**BRYAN J. DOLAN**  
VP, Nuclear Plant Development

**Subject:** Duke Energy Carolinas, LLC  
William States Lee III Nuclear Station – Docket Nos. 52-018 and 52-019  
AP1000 Combined License Application for the  
William States Lee III Nuclear Station Units 1 and 2  
Supplemental Response to Request for Additional Information (RAI No. 50)  
Ltr# WLG2010.03-02

**Lee Nuclear Station Supplemental Response to Request for Additional Information (RAI)**

**New Figure E-2: Day Care Centers, Medical Facilities and Correctional  
Facilities within the WLS EPZ**

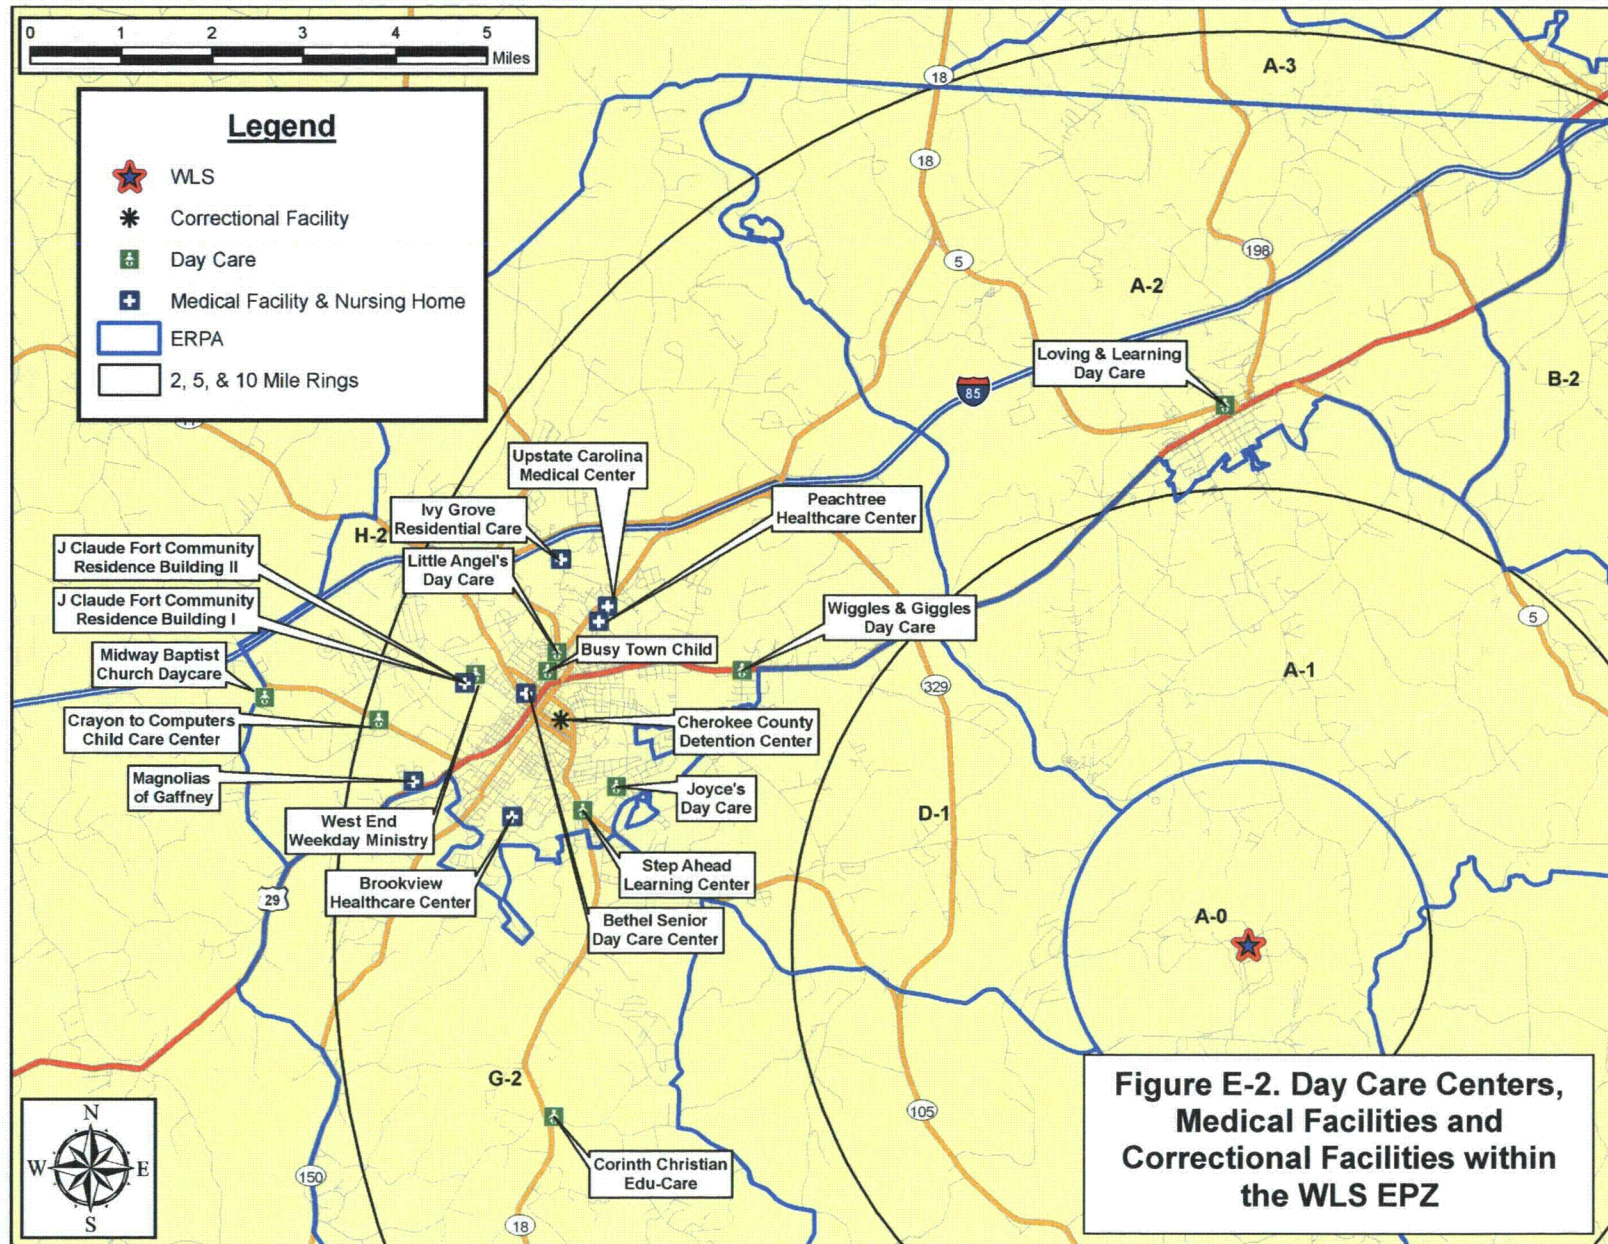
As noted in the December 9, 2008 response to RAI 13.03-026 (Reference 2), five additional medical facilities were identified within the Lee Nuclear Station EPZ. The November 25, 2008, response to RAI 13.03-032 provided a new figure identified as Figure E-2, "Day Care Centers, Medical Facilities and Correctional Facilities within the WLA EPZ" which mapped the special facilities within the Lee Nuclear Station EPZ. The figure, as provided, did not include the five additional facilities identified in the response to RAI 13.03-026 (Reference 2). This supplemental response provides a revised Figure E-2, which includes the five additional facilities.

Lee Nuclear Station ETE Report (Rev 1) will be updated to include Figure E-2, "Day Care Centers, Medical Facilities and Correctional Facilities within the WLS EPZ", as provided in Attachment 1 to this supplemental response. Figure E-2 (Attachment 1) as provided in this supplemental response updates the Figure E-2 submitted in the initial response to this RAI provided in Duke Energy letter WLG2008.11-11, dated November 25, 2008.

Revise Appendix E of the Lee Nuclear Station ETE Report (Rev 1) to add the updated Figure E-2 as provided in Attachment 1.

**Figure 7-67. Evacuation Time Estimates for WLS  
Summer, Midweek, Midday, Good Weather  
Evacuation of Region R03 (Entire EPZ)**

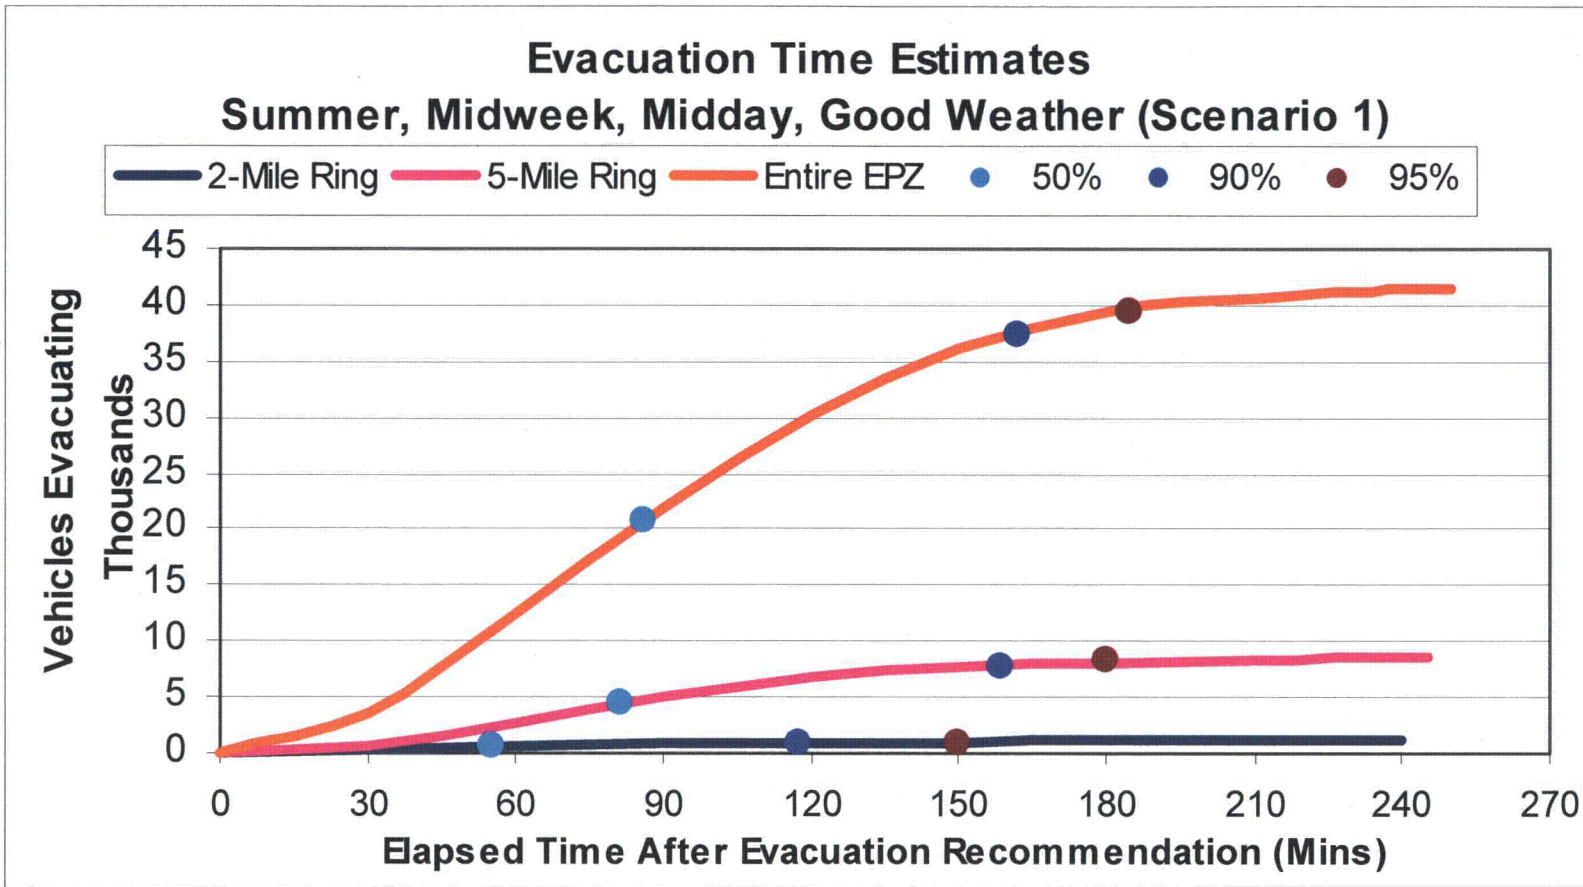
Figures 7-3 through 7-6, "Areas of Traffic Congestion" as referenced in Section 7.3, "General Population Evacuation Time Estimates," are said to imply that evacuation is a continuous process; this is not obvious from the figures. Section 7.3 states that Figure 7.7, "Evacuation Time Estimates for WSL Summer, Midweek, Midday, Good Weather Evacuation of Region 03 (Entire EPZ)" indicates that there is a "long tail" in the rate at which traffic flows out of the indicated area; the idea may be correct but the figure does not show this. Provide additional explanation or a figure that does show the indicated information.

The new congestion patterns are provided and discussed in the supplemental response to RAI 13.03-048 (Enclosure 19 of this letter). Figure 7-6 has been deleted as a result of the new simulation runs and Figure 7-7 has been renumbered as Figure 7-6, "Evacuation Time Estimates for WSL Summer, Midweek, Midday, Good Weather Evacuation of Region 03 (Entire EPZ)." (Attachment 1)

As shown in the new Figure 7-6, a "long tail" still exists for the evacuation. The slope of the curve is small during the first 30 minutes since much of the EPZ population has not yet mobilized. Between 30 minutes and 180 minutes, the slope is steeper as more people have completed their mobilization activities and have evacuated the region. Between 180 minutes and 250 minutes the slope of the plot decreases significantly as only those people who take significantly longer to mobilize remain. Ninety-five percent of the EPZ population evacuates during the first 190 minutes; however, the remaining 5% of the population requires an additional hour to evacuate. In summary, the "long tail" of the curve is that area between 180 and 250 minutes where the slope of the curve has decreased to the point of being nearly horizontal.

Figure 7-7, "Evacuation Time Estimates for WLS Summer, Midweek, Midday, Good Weather Evacuation of Region 03 (Entire EPZ)" discussed in the December 17, 2008, response will be revised and renumbered as described in the supplemental response to RAI 13.03-033 (Enclosure 12 of this letter). The curves of renumbered Figure 7-6 are essentially horizontal past 3 hours (zero slope indicates zero flow rate), for the evacuation of the entire EPZ (Region R03) in Scenario 1 as opposed to the 4 hours discussed in the December 17, 2008 response.

**Figure K-26.**  
**Link-Node Analysis**  
**Network**  
**Inset 25**

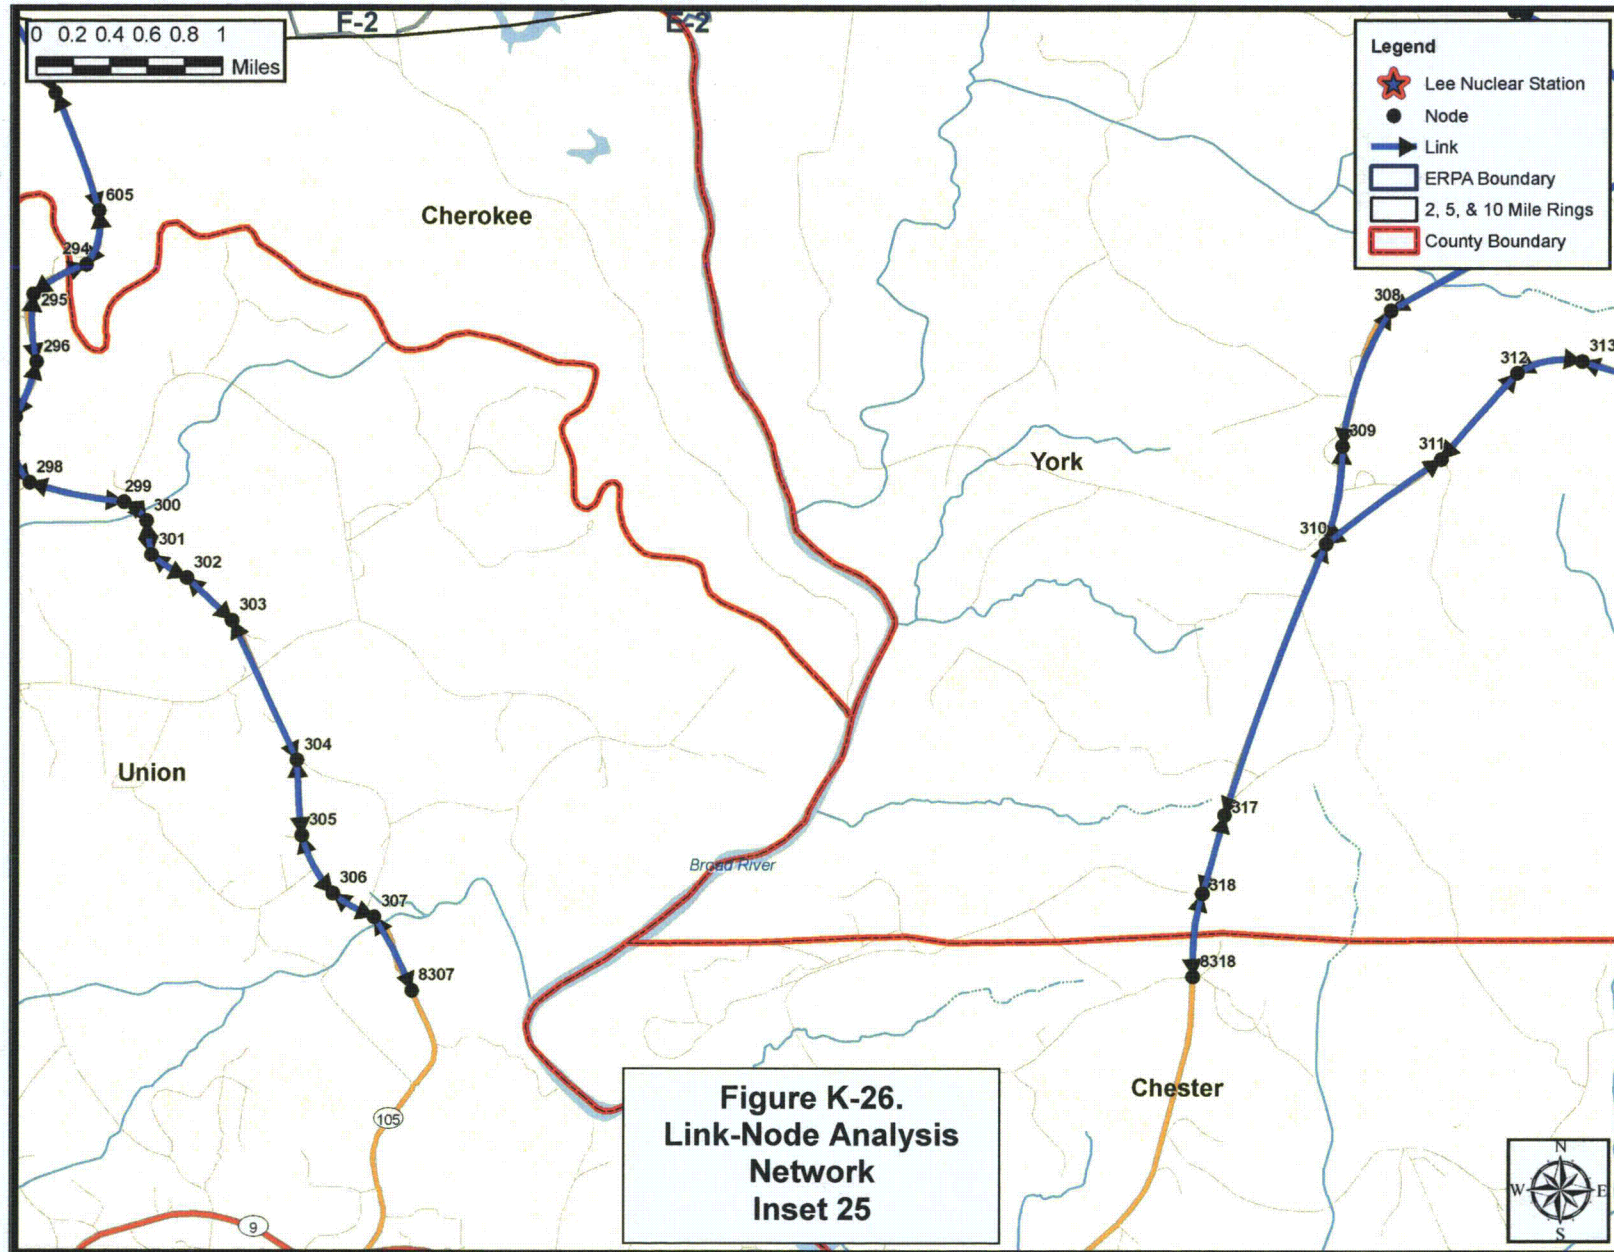
Provide a legible map that includes the nodes identified on Figure 1-2, "Lee Link-Node Analysis Network," and in Appendix K, "Evacuation Roadway Network Characteristics." The nodes must be annotated to support the review. A larger scale is necessary. Provide a roadway map that includes the sector and quadrant boundaries.

In response to RAI 13.03-038 (Reference 1) Duke Energy provided Figure 1-2, "Lee Link-Node Analysis Network", in electronic format to support the review of the Lee Nuclear Station ETE Report (Rev 1). This supplemental response provides the same information (Attachment 1) in the form of 27 figures (1 overview and 26 detailed segments) that will be added to Appendix K in Revision 2 of the Lee Nuclear Station ETE Report. In addition, Section 1 of the Lee Nuclear Station ETE Report (Rev 1) will be revised to add text to the subsection titled "Developing the Evacuation Times Estimates" describing the application of the material as described in Attachment 2.

Given the scale of Figure 1-2, it is not feasible to identify the links and nodes to enable the reader to relate to the information presented in Appendix K. The directional arrows on the links and the node numbers have been removed from Figure 1-2 to clarify the figure. The detailed figures provided in Appendix K depict the analysis network with directional arrows shown and node numbers provided.

Figure 5-2. Evacuation Mobilization Activities

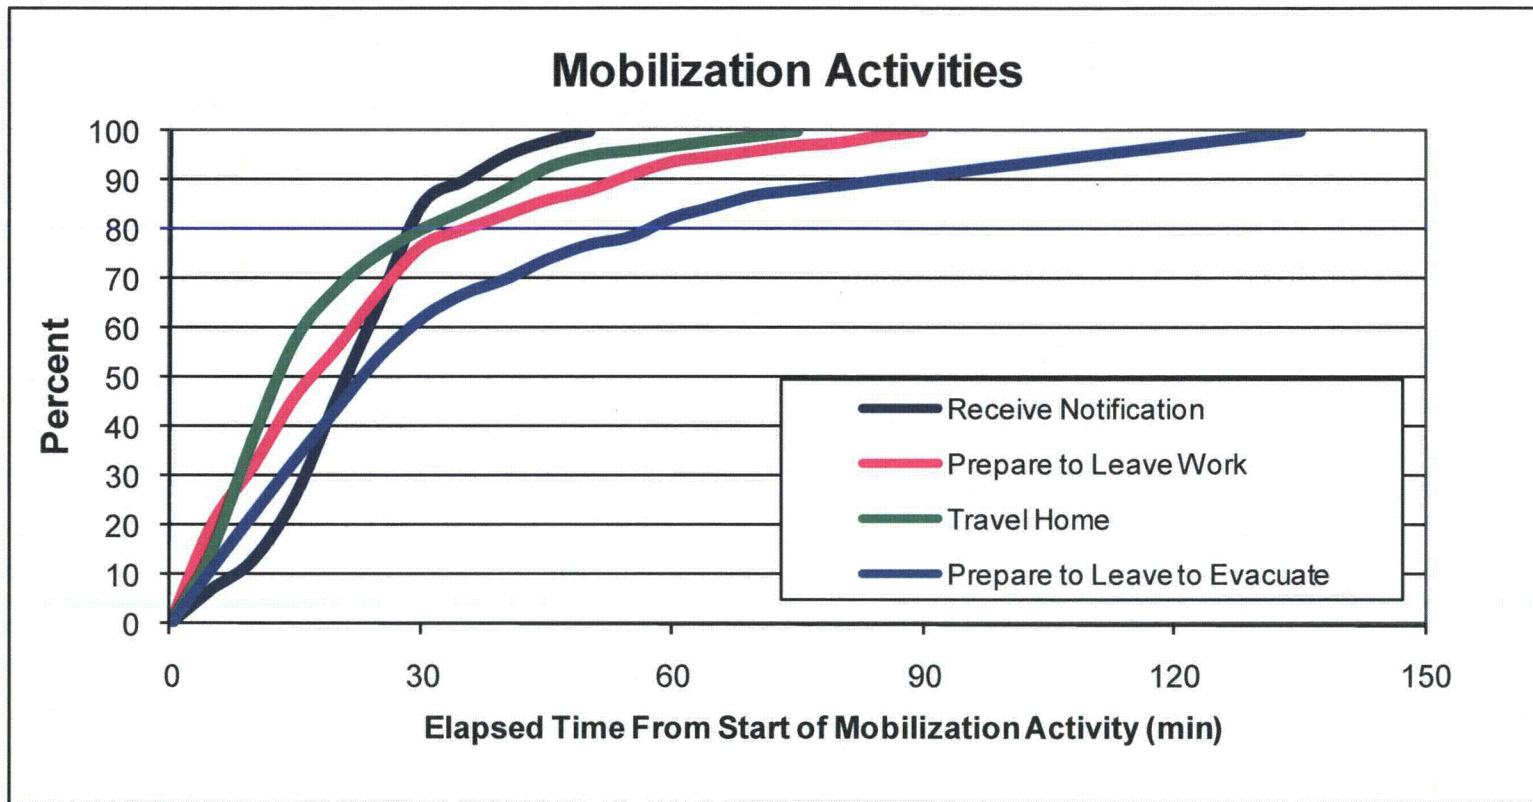
- e. In Figure 5-2, "Evacuation Mobilization Activities," the time to prepare home is identified as approximately 140 minutes, however Appendix F, page F- 10, would indicate this should be a minimum of 210 minutes and may be as long as 360 minutes. Explain why Figure 5.2 indicates 140 minutes. If necessary, reconcile Figure 5-2 with the comments above on other tables in Section 5.

Figure 5-2 and Figure 5-3 will be revised to accurately reflect the inputs to the model, the description of activities and adjust the x-axis to remove unnecessary portions of the graph.

- Revise Figure 5-2 of the Lee Nuclear Station ETE Report (Rev 1) as provided in Attachment 1.
- Revise Figure 5-3 of the Lee Nuclear Station ETE Report (Rev 1) as provided in Attachment 2.

**Figure 5-3. Comparison of Trip Generation Distributions**

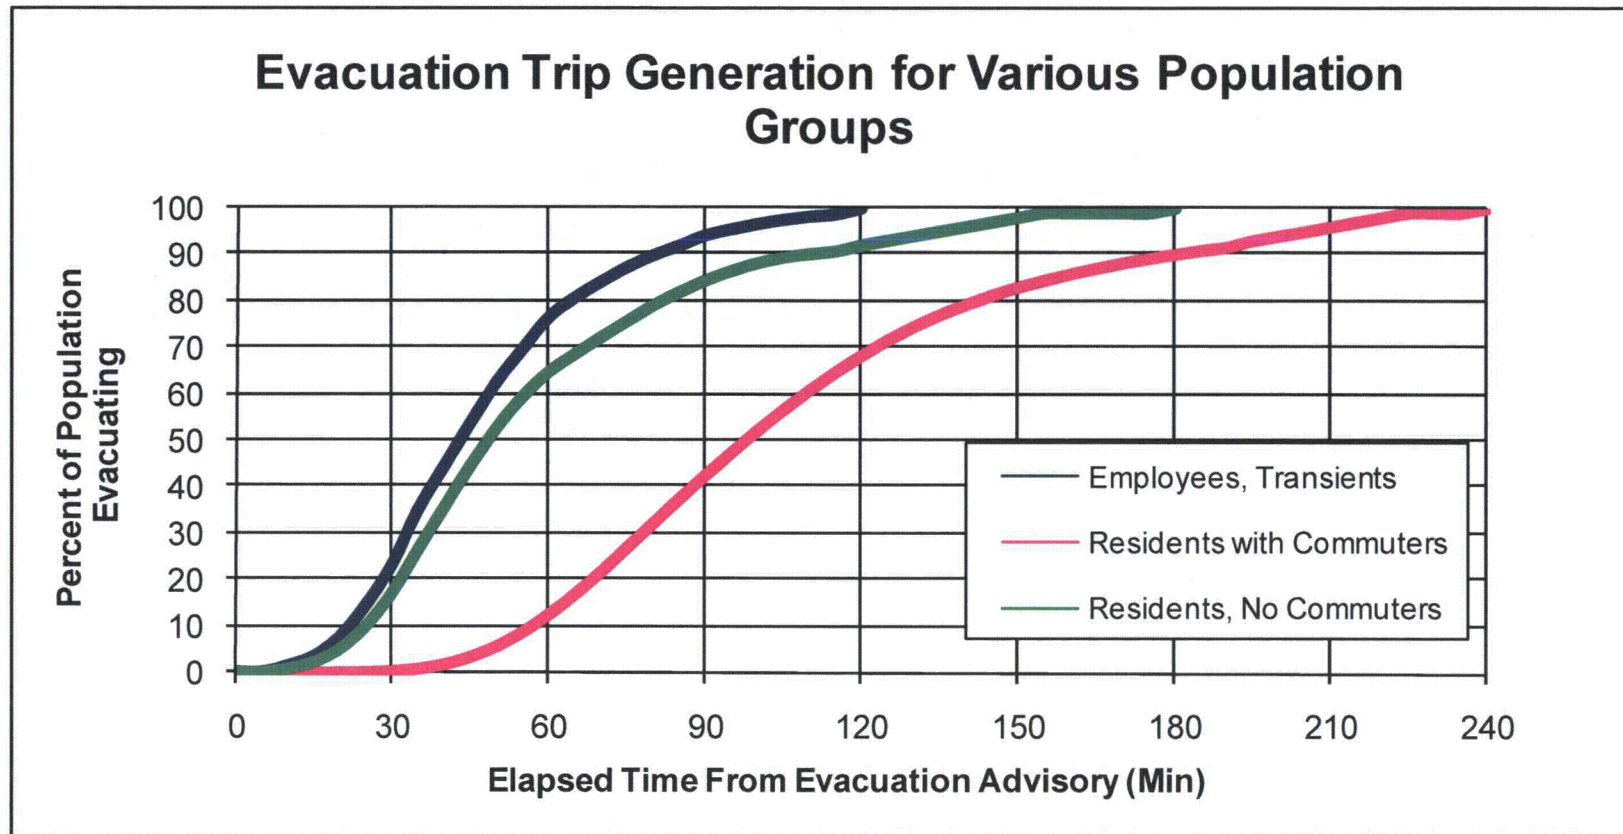
- f. If necessary, reconcile Figure 5-3, "Comparison of Trip Generation Distributions" and Table 5-8, "Trip Generation for the EPZ Population," with the comments on other tables in Section 5.
